Proposal Content Document

Proposal title	Greenbushes Lithium Mine: Waste Rock Landforms, Salt Water Gully Dam and additional clearing for infrastructure.
Proponent name	Talison Lithium Australia Pty Ltd
Short description	Expansion of the existing Greenbushes lithium operations to incorporate the S2 WRL, S8 WRL, SWG Dam and additional mine infrastructure.

Figure 1-2: Changes between existing DE and Proposed s43A DE

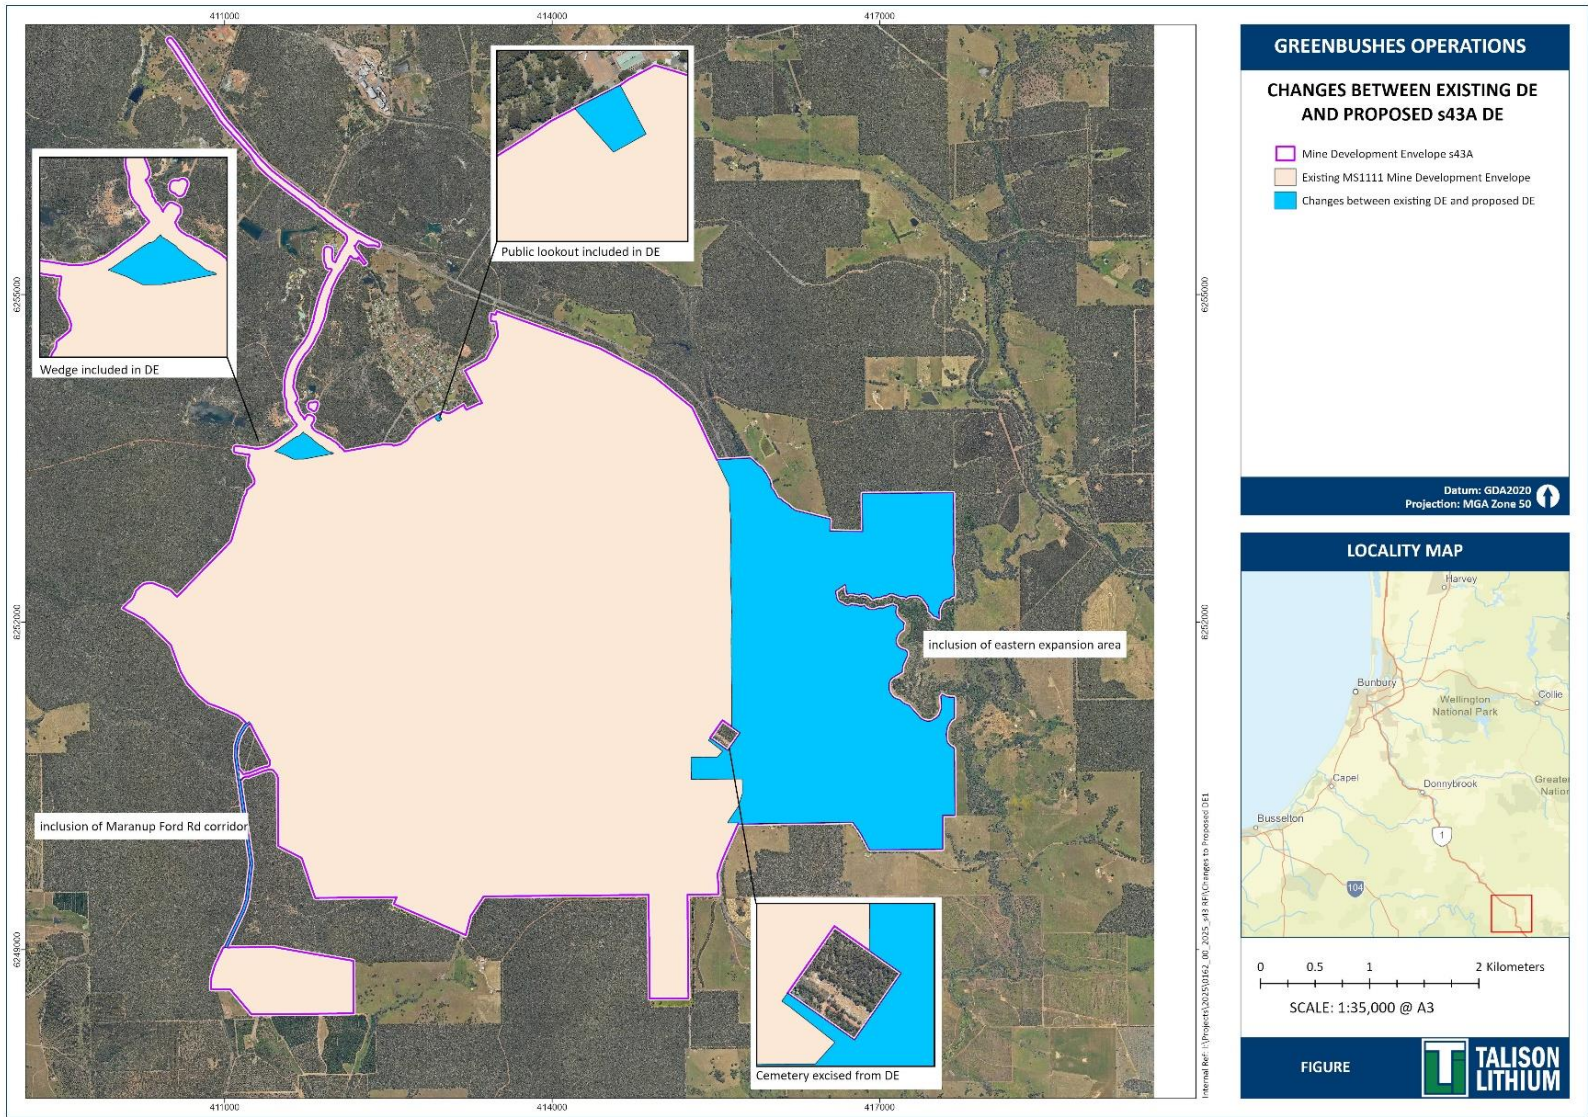
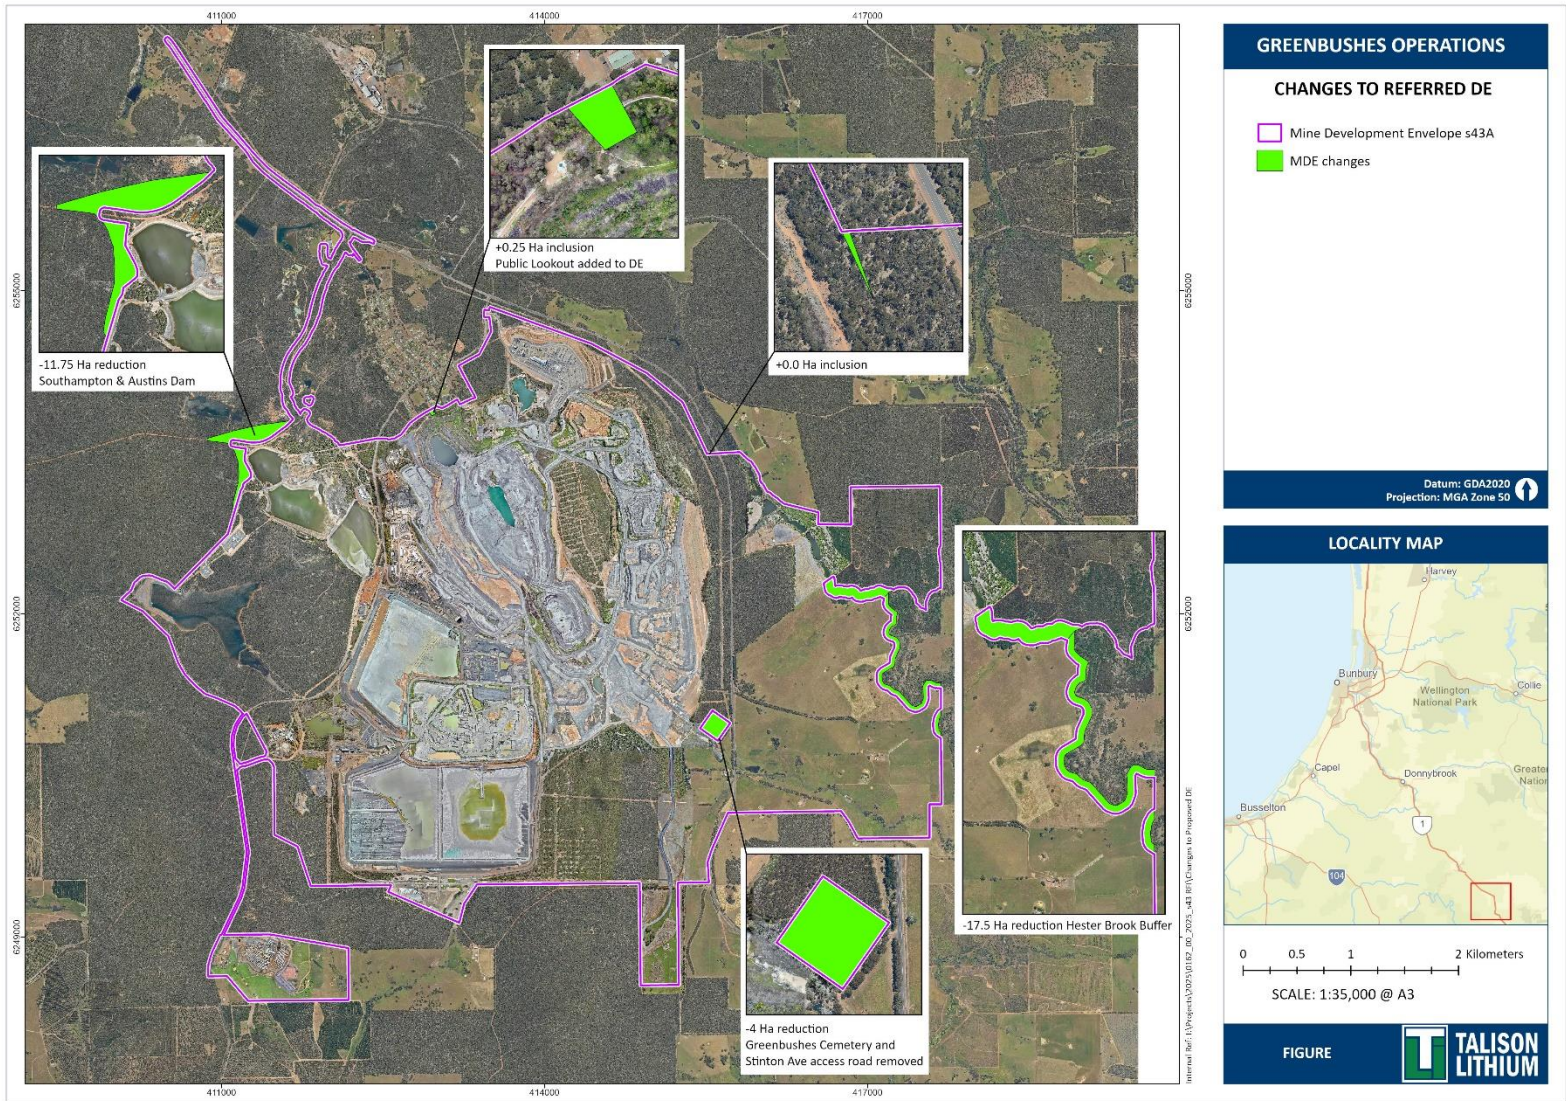
Proposal element	Location/ description	Existing proposal extent, capacity or range	Referred proposal extent, capacity or range	Proposed amendments	Total proposal extent, capacity or range
Water management infrastructure	Figure 1-4.			No change to footprint.	
Supporting infrastructure corridors	Figure 1-4.			No change to footprint.	
CGP4 Infrastructure	Figure 1-4.			No change to footprint. Reference to workshops and laydown have been removed. The overall disturbance footprint remains unchanged.	
Rehabilitation material stockpile (RMS) area	Figures 1-4 and 1-10.			1 ha increase in the clearing of native vegetation. Note: This figure excludes the clearing of plantation associated with the expansion of the RMS area.	
Mixed use area	N/A			Removal of this proposal element as it will be part of the S2 WRL. No change to clearing disturbance	
Cemetery	Figure 1-2 and 1-3.			4 ha reduction DE to excise the cemetery

Proposal element	Location/ description	Existing proposal extent, capacity or range	Referred proposal extent, capacity or range	Proposed amendments	Total proposal extent, capacity or range
Mine lookout	Figure 1-2 and 1-3.			0.25 ha increase to DE to include lookout, no additional clearing required.	
Hester Brook buffer	Figure 1-3.			17.5 ha reduction in DE to maintain a 50m buffer along the length of Hester Brook registered heritage site	
Operational Elements					
Damming and abstraction of surface water for mine site water supply.	Figures 1-1, 1-2, 1-4 and 1-8.	N/A	Abstraction of up to 1 GL/a from Saltwater Gully Dam.	No change.	Abstraction of up to 1 GL/a from Saltwater Gully Dam.
Waste Rock Landform Construction		Waste Rock Landform height of 330 m AHD and area of 355 ha.	WRL height of 330 m AHD and area of 727 ha (includes existing Floyds WRL, S2 WRL and S8 WRL).	Increase of WRL footprint by 63 ha, including removal of mixed use element and larger S8 footprint	WRL height of 330 m AHD and area of 790 ha (includes existing Floyds WRL, S2 WRL and S8 WRL).

Figure 1-5: Prior disturbance of 31ha of Previous Mine Disturbance and Rehabilitation Areas

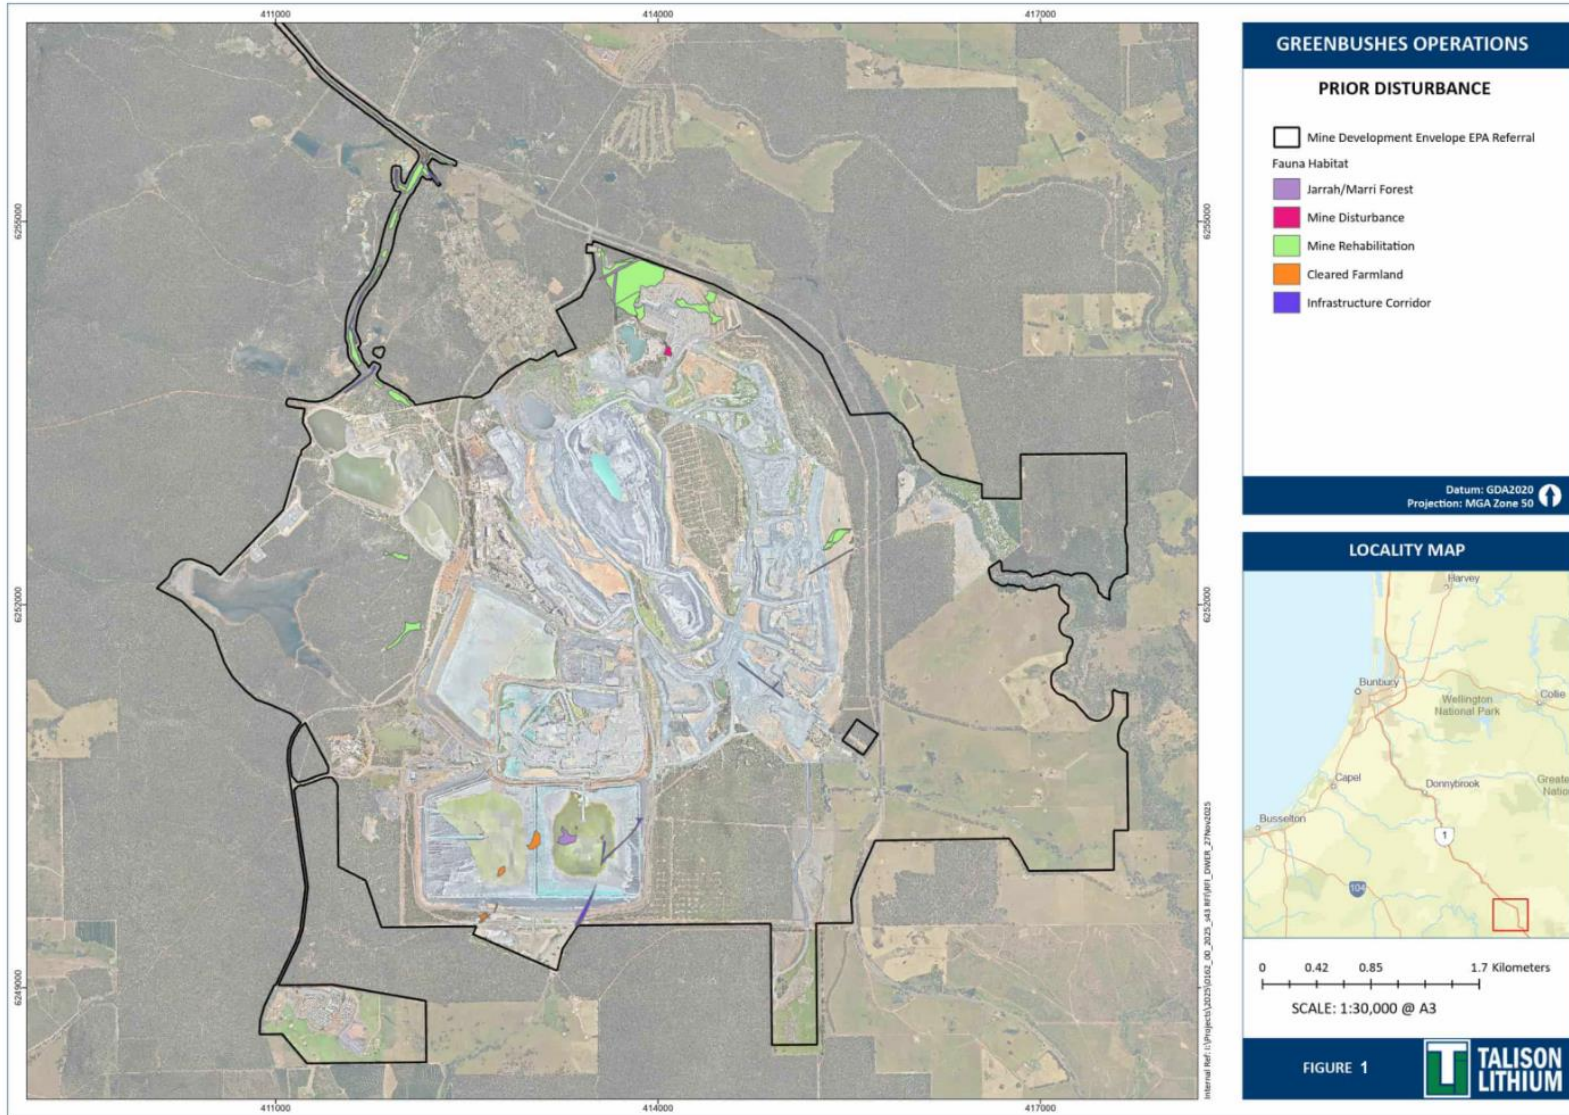
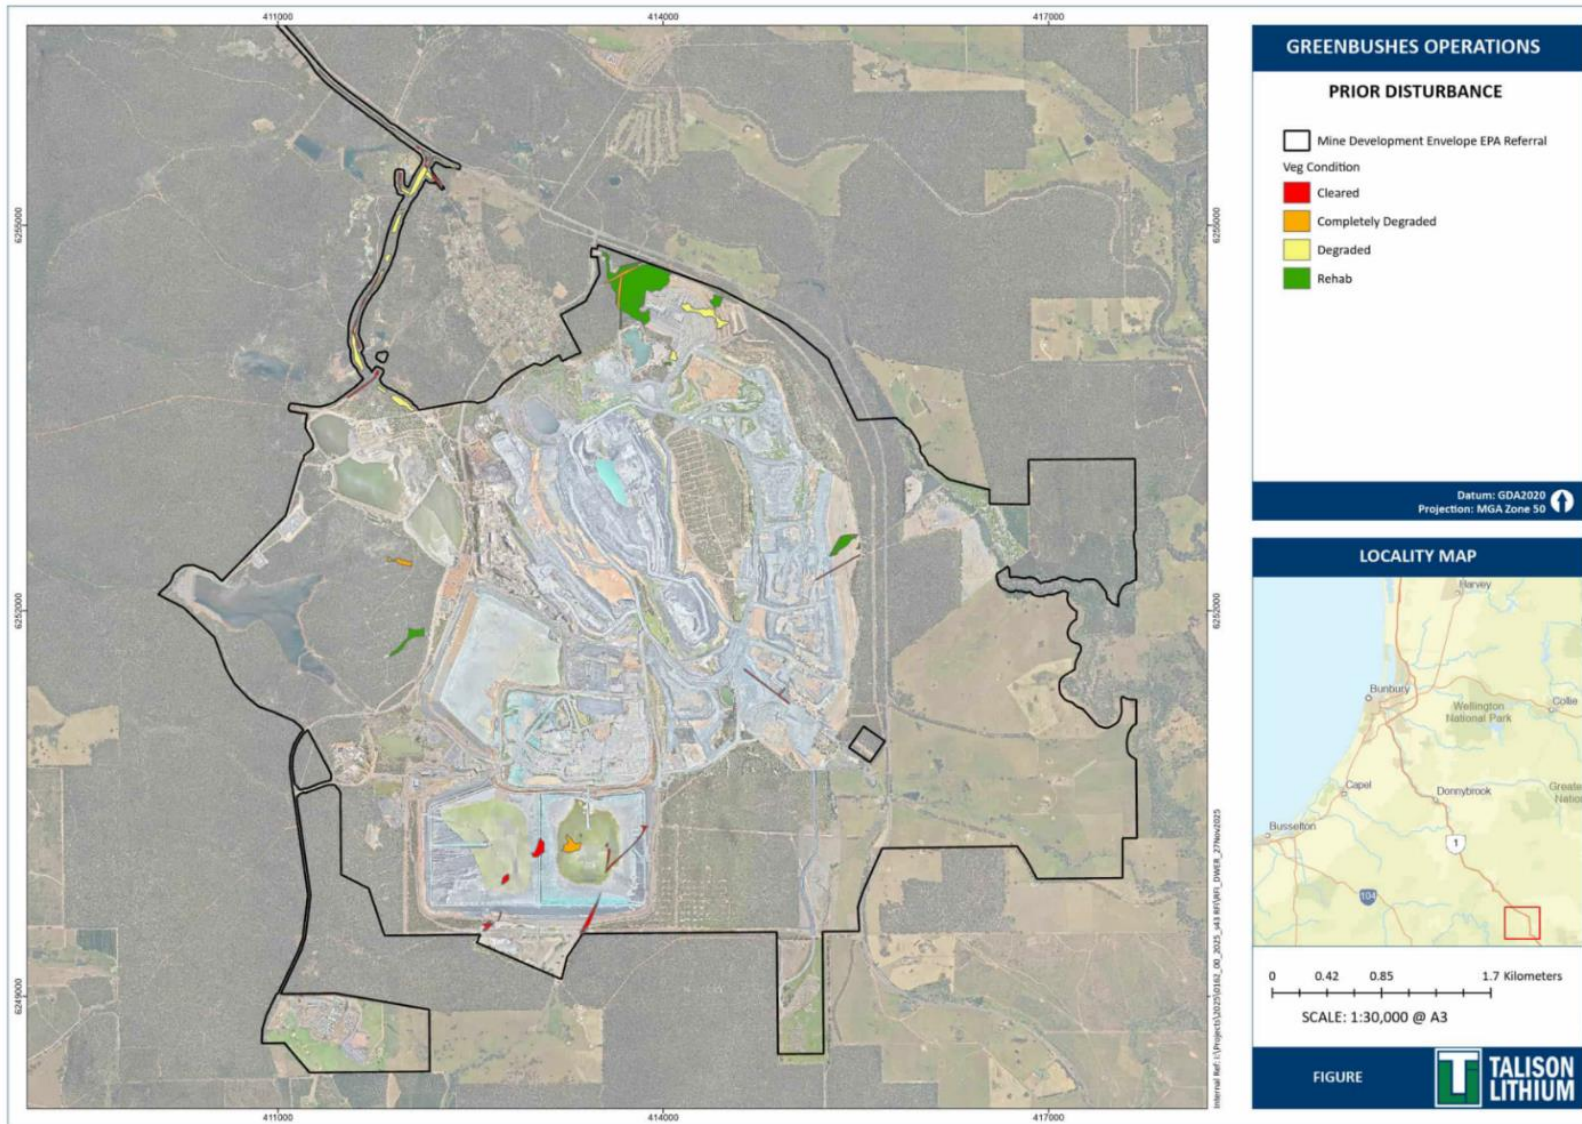
Proposal element	Location/ description	Existing proposal extent, capacity or range	Referred proposal extent, capacity or range	Proposed amendments	Total proposal extent, capacity or range
Mine services area (existing mine infrastructure)	Figure 1-5 and 1-6.			Talison is increasing the clearing of previous mine disturbance and rehabilitation areas that relate to the MSA to ensure that MS1111 accurately captures all land clearing already completed, as well as future clearing required for the proposed expansion. This includes an increase of 31 ha in areas of previously disturbed by mining and rehabilitation activities	
Waste rock landforms (S2 & S8)	Figure1-7.			<p>The reduced size of SWG Dam enables a small increase in the footprint of the S8 WRL. S2 increases due to the removal of the mixed use area element. Changes to footprint include</p> <ul style="list-style-type: none"> • S2 WRL increases by 60.5 ha

Figure 1-7: Proposed Changes to WRL S2 and S8

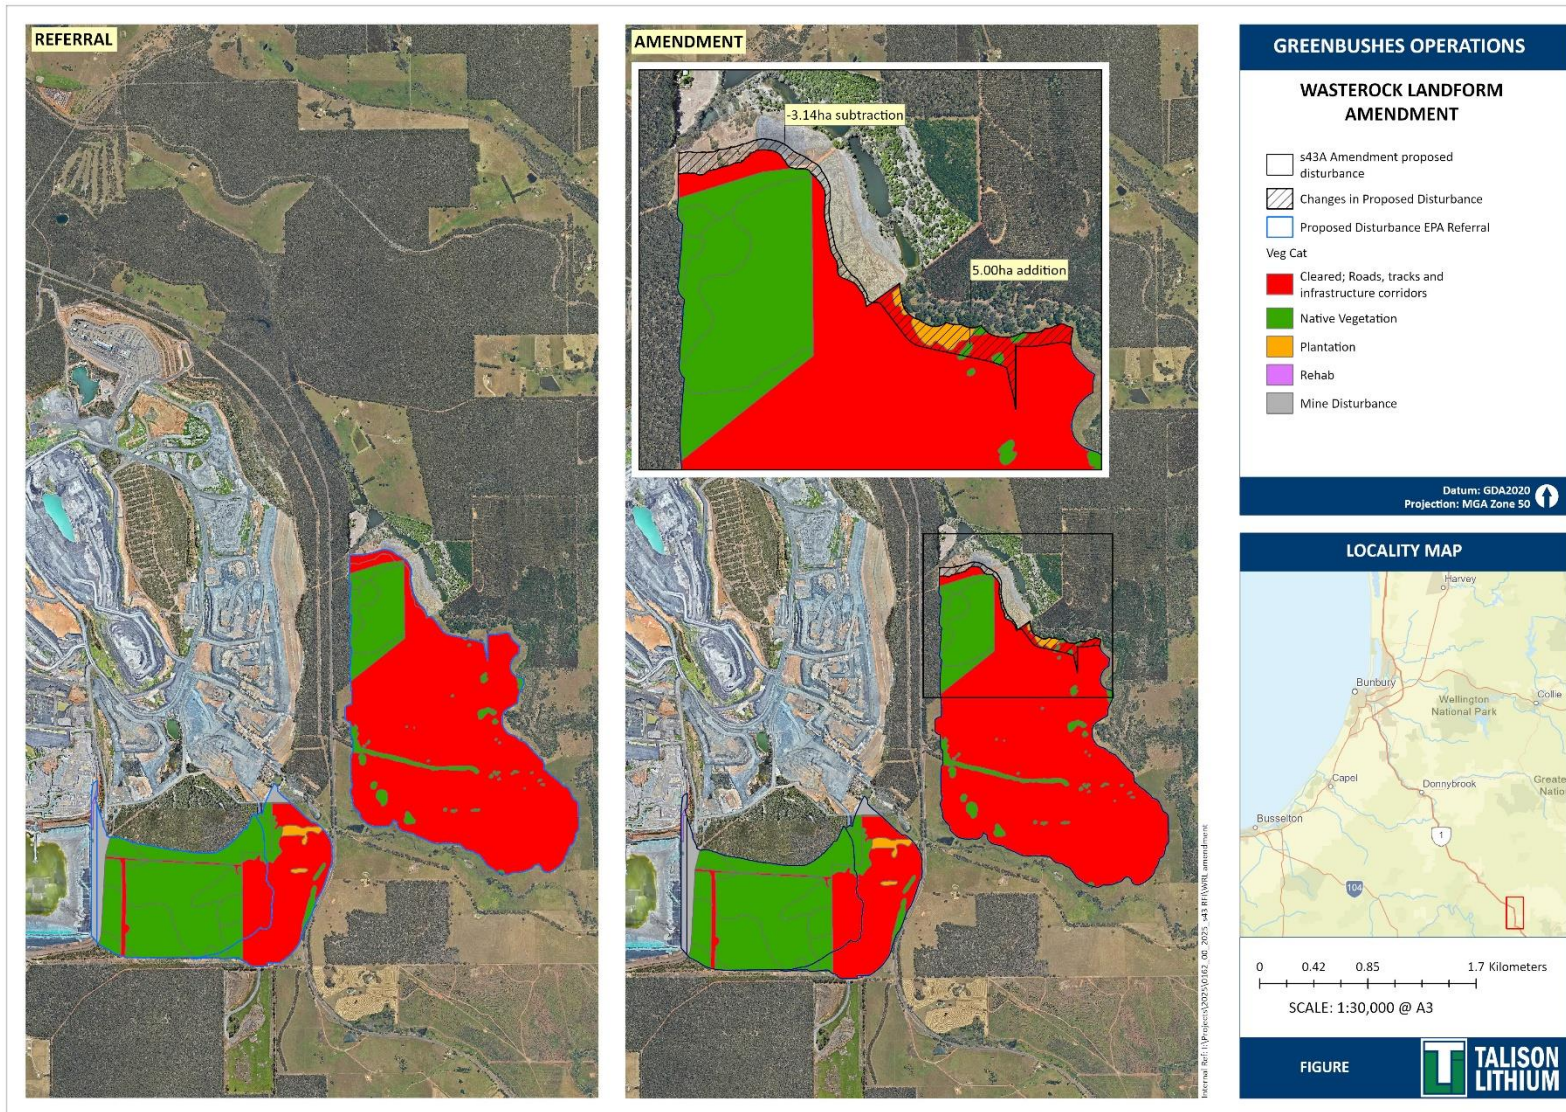
Proposal element	Location/ description	Existing proposal extent, capacity or range	Referred proposal extent, capacity or range	Proposed amendments	Total proposal extent, capacity or range
				<ul style="list-style-type: none"> S8 WRL increases by 2 ha No change to overall disturbance footprint for this element 	
Saltwater gully dam	Figure 1-8.			Reduction of dam area to avoid heritage identified by Wagyl Kaip survey in November 2025. Reduction of 3 ha of native vegetation clearing and reduction 4 ha of previous mine disturbance and rehabilitation areas	
Southampton and Austins dams	Figures 1-3 and 1-9.			<p>2 ha reduction in clearing of native vegetation and 1 ha reduction in clearing of previously rehabilitated areas.</p> <p>Dam raise clearing reduces by 3 ha in total.</p> <p>11.75 ha reduction to the DE.</p>
